SENSITIVITY OF SEISMIC HAZARD RESULTS  
AT MILLSTONE TO LLNL STUDY ASSUMPTIONS  
ON ATTENUATION AND SEISMICITY

FINAL REPORT  
TO  
NORTHEAST UTILITIES

# Dames & Moore

June 15, 1984

Figure 18  
Seismicity Data, Zone 31 of Expert 2

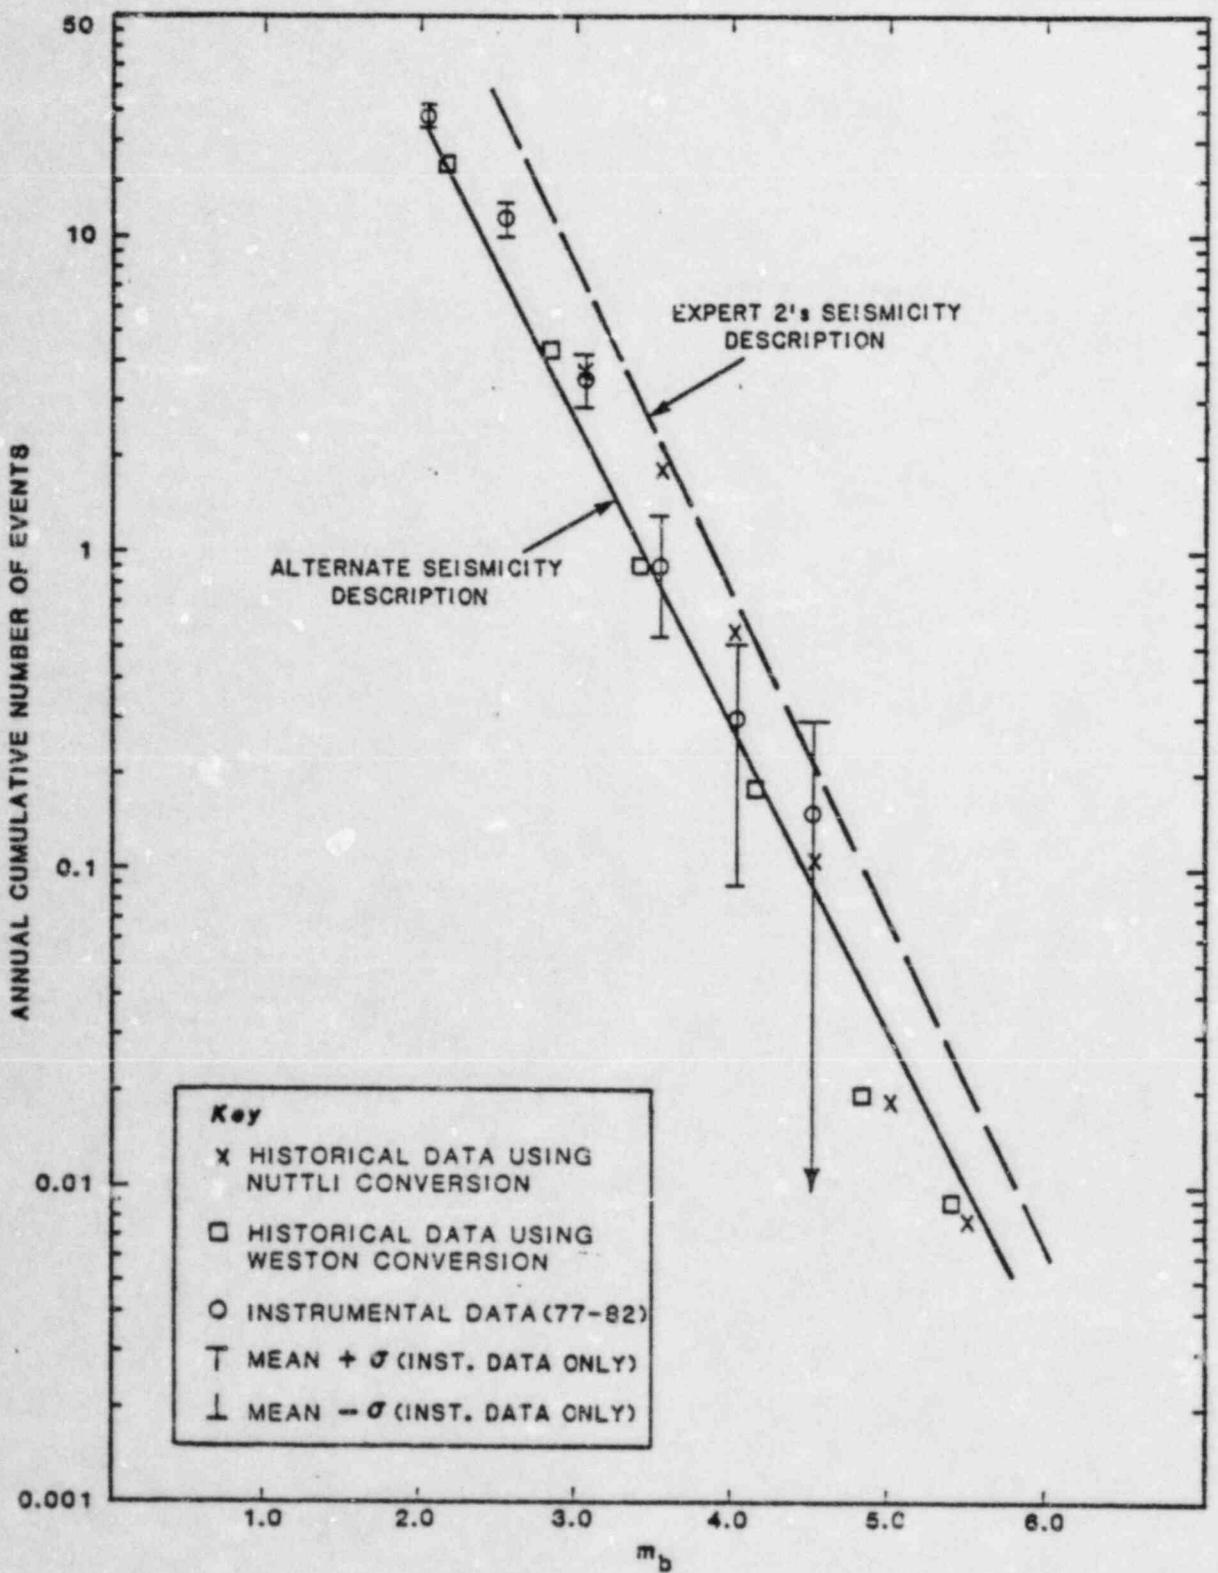
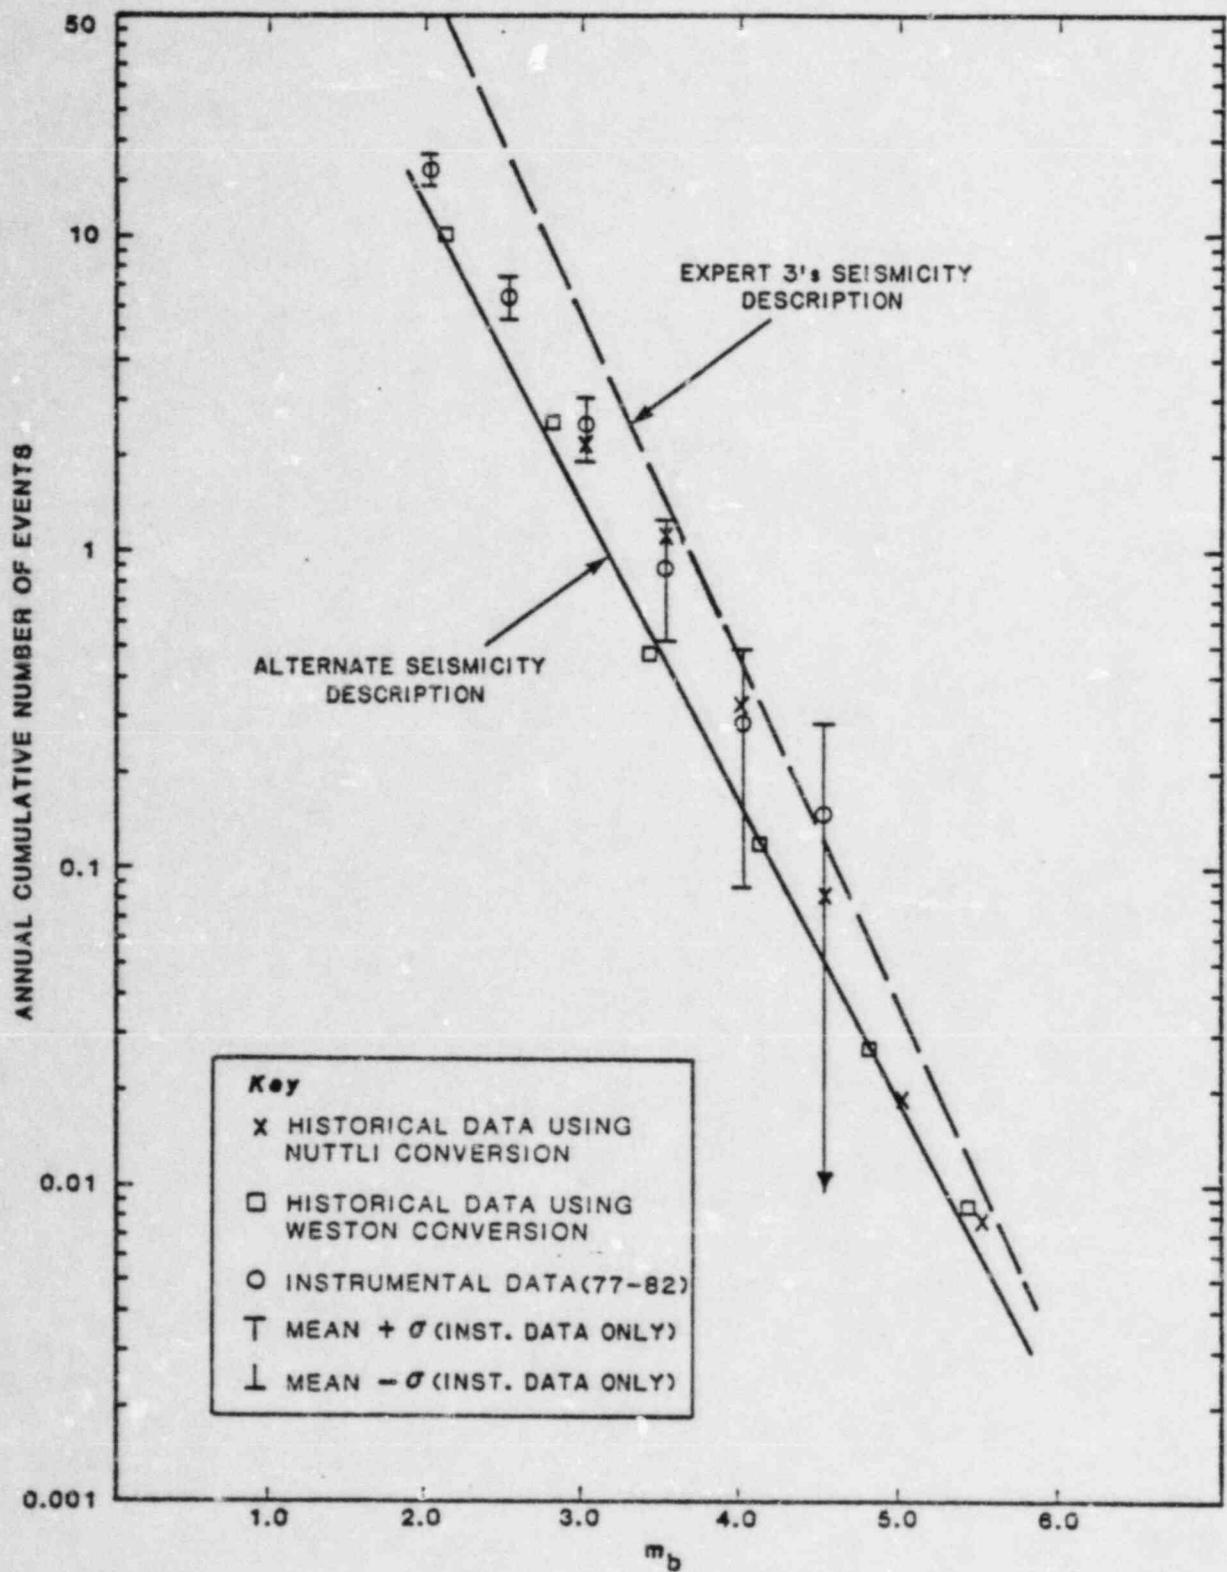
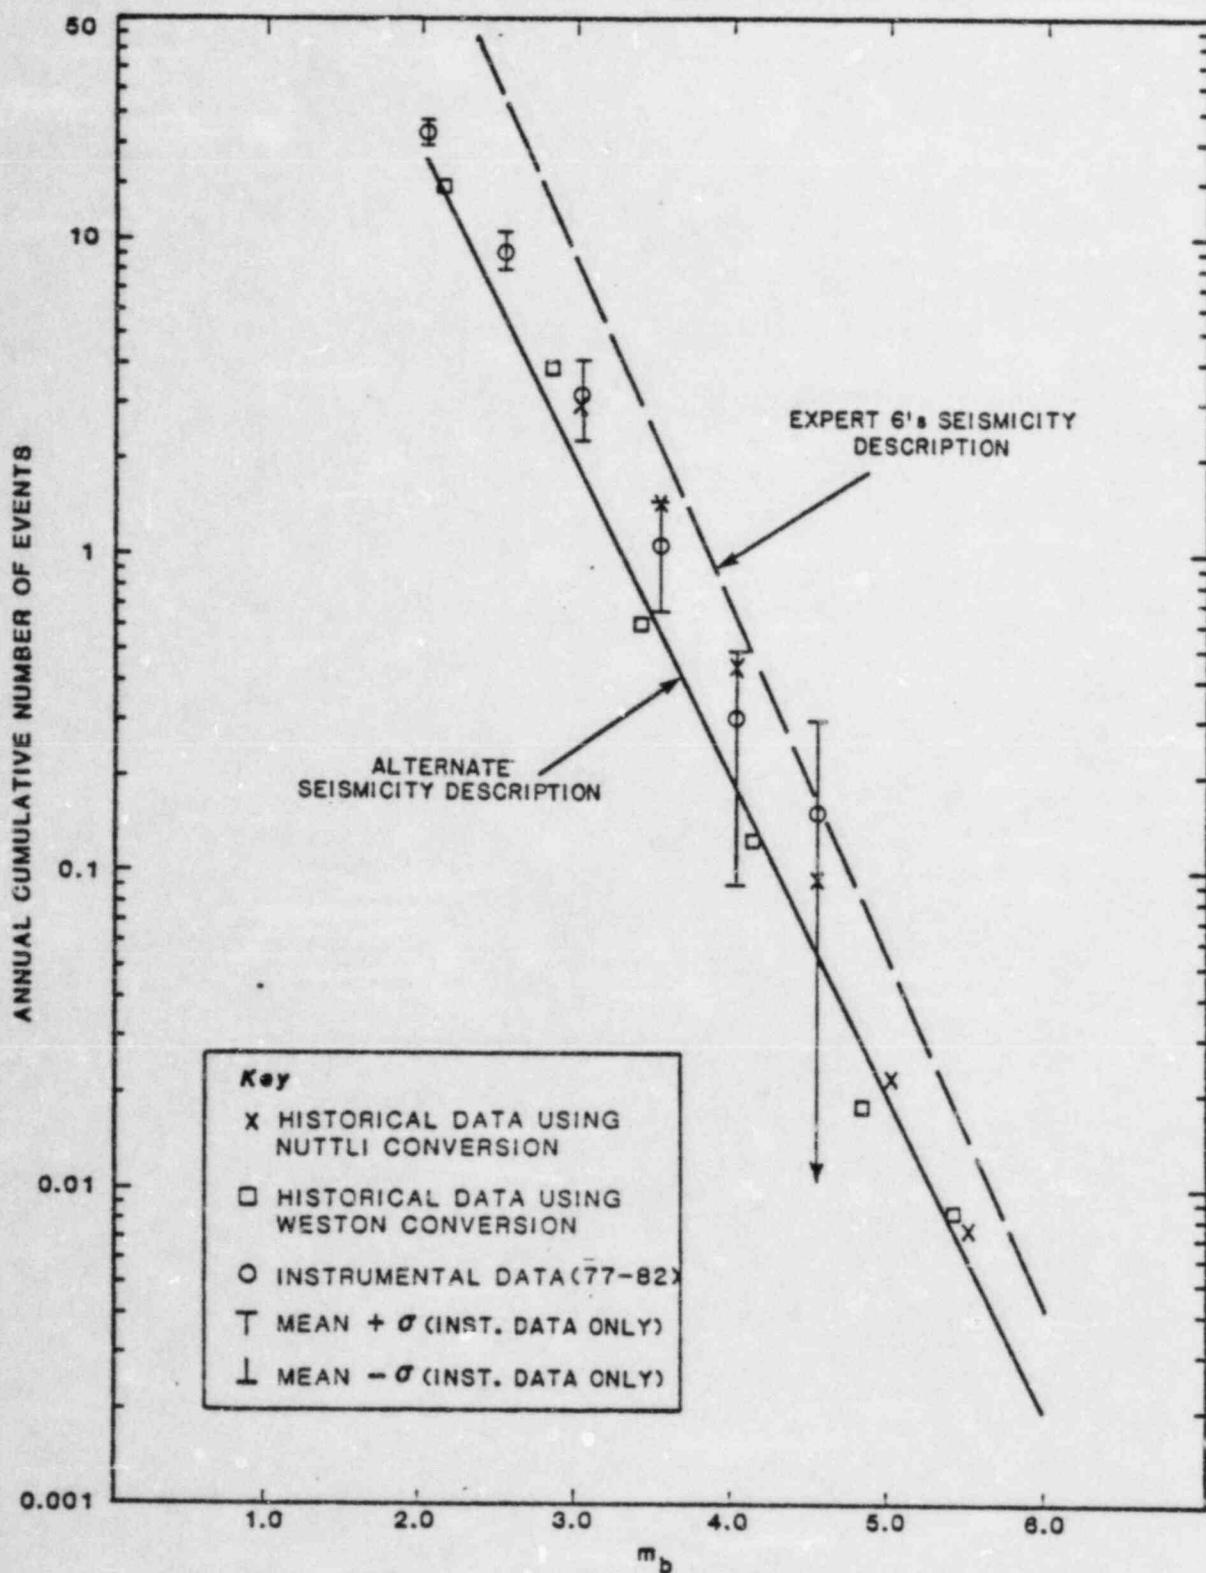
Figures 18 through 20 show seismicity data for zones 31, 7, and 4 specified by experts 2, 3, and 6, respectively. These zones were selected for presentation because they include only the New England area where data from the New England seismic net are relatively complete down to the magnitude 2.0 level at least, since 1976. Three sets of data are shown on these figures. The x's indicate cumulative rates of seismicity from historical data using the Nuttli-Herrmann conversion to estimate  $m_b$  from intensity:

The squares in Figure 18 through 20 indicate cumulative rates calculated in an equivalent manner using equation (2) instead of equation (3) to estimate  $m_b$  from  $I_0$ . The circles indicate cumulative rates calculated from instrumental seismicity from the New England seismic net (Pulli, personal communication,

1984) for the period October 1975 to March 1982. Both sets of data generally lie below the rates which are obtained if the Nuttli-Herrmann conversion is used for New England. Note that the instrumental rates at  $m_b = 4.5$  and  $4.0$  should not be given much weight; they are determined from occurrences of one and two earthquakes, respectively. On the other hand, the rate for  $m_b = 2.0$  is determined from 140 or 150 earthquakes. The bars attached to the circles show one-standard-deviation bounds, calculated as the square root of the number of observations divided by the interval of completeness. The bars graphically reinforce the last two observations about small and large sample sizes.

The dashed line on the figures indicated the seismicity distribution implied by each expert's choice of a and b-value. (The use in the LLNL study of a non-linear range between  $m_b = 3.75$  and some other value of  $m_b$  specified by each expert where the semi-logarithmic plot becomes linear -- see LLNL report page A40 -- has little effect and is not followed in this study.) The dashed lines in Figures 18 through 20 are consistent with each expert's specification of a and b-value. These dashed lines are generally conservative estimates of the data, for the reasons discussed above. For example, the x's in Figures 18 through 20 at  $m_b = 3.5$  were determined using all earthquakes given to the seismicity experts by LLNL and which were represented by LLNL as all events with  $m_b > 3.75$ . Thus there may be a quarter-magnitude-unit bias in the dashed lines compared to the x at  $m_b = 3.5$ .

The solid lines indicate the fit to the squares obtained by the maximum likelihood procedure. This representation of seismicity lies below that indicated by each expert, and is more consistent with instrumental seismicity rates. In particular, the solid lines represent relatively well the cumulative rate of activity at  $m_b = 2.0$  (which is well-constrained with instrumental data) and for  $m_b \geq 4.5$  (where differences from the conversion of historical data to magnitude by different means are relatively small and hence not controversial). Thus the solid lines are reasonable alternatives with which to examine the sensitivity of hazard results to the experts' choices of activity rates (and b-values), vis-a-vis others.

Figure 21  
Median Acceleration Hazard Curves,  
Base Case and Alternate Activity Rates

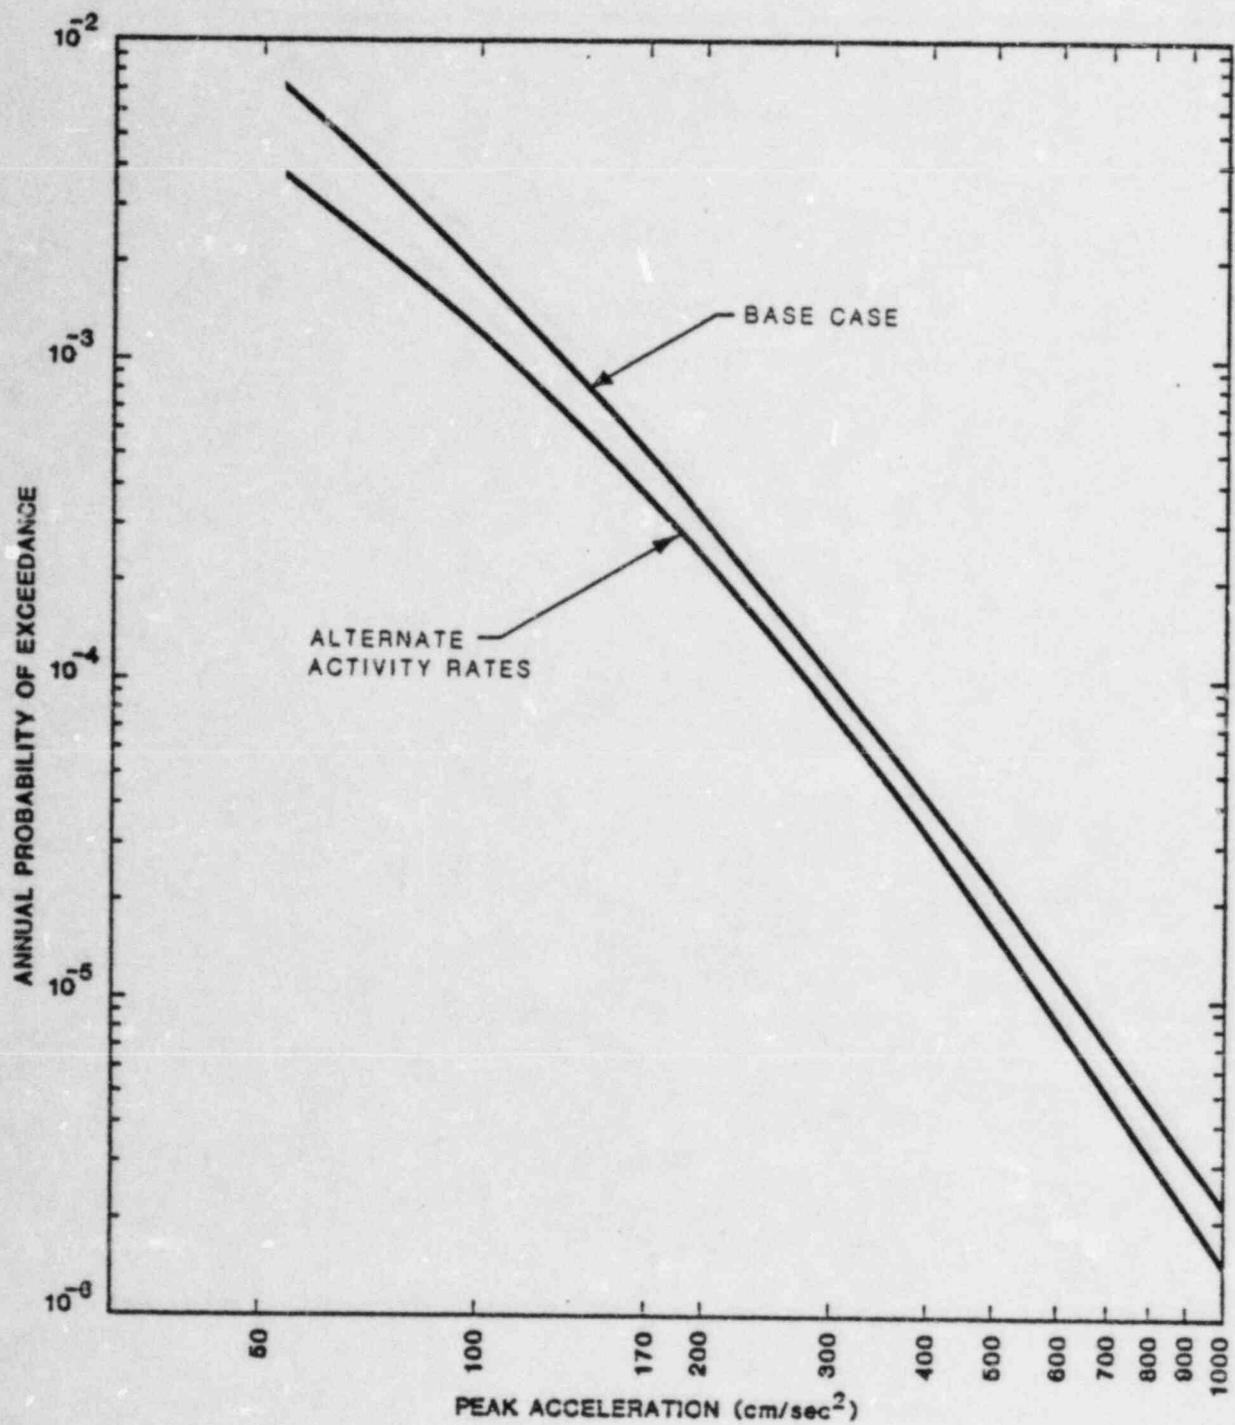
Figure 21 shows the median acceleration hazard curve over all eleven seismicity experts and six attenuation functions for Millstone, obtained using the alternative activity rates and b-values. Also shown is the base case, for comparison. In general there is a reduction of 25% in probability or 10% in acceleration implied by the alternative rates. Spectral velocity results are similar and are shown in Figure 22.

Figure 23  
 Median Acceleration Hazard Curves,  
 Base Case,  $m_{b,\min} = 4.5$  and 5.0

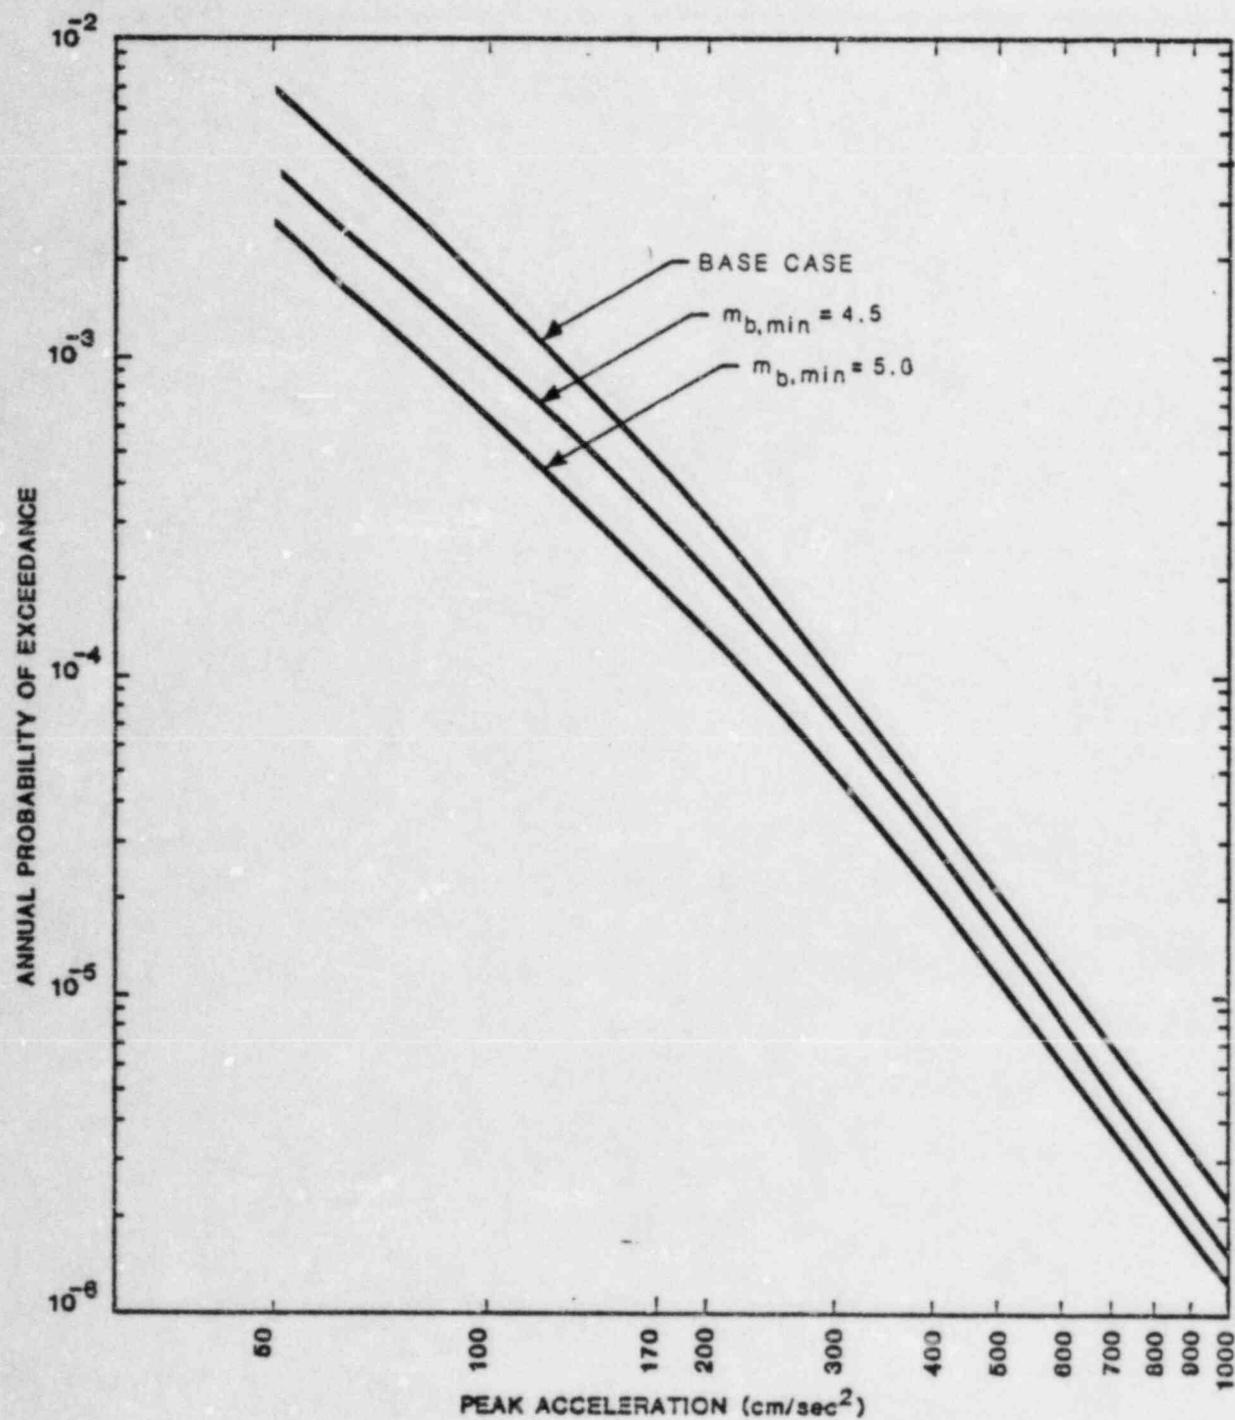
The effect of choosing different lower bounds was examined by using the experts' a and b-values, computing an activity rate for each zone assuming  $m_{b,min} = 5.0$ , and recalculating seismic hazard for that lower bound and activity rate. The process was repeated for  $m_{b,min} = 4.5$ . The results for each case are shown in Figure 23. The median curve for  $m_{b,min} = 5.0$  is about 55% lower in probability (25% lower in acceleration) than the base case. The changes for  $m_{b,min} = 4.5$  are 35% in probability and 15% in acceleration. Thus the choice by LLNL of  $m_{b,min} = 3.75$  has a major effect; the use of a more realistic lower bound for structures and mechanical equipment would lead to significant changes in the median hazard curve.
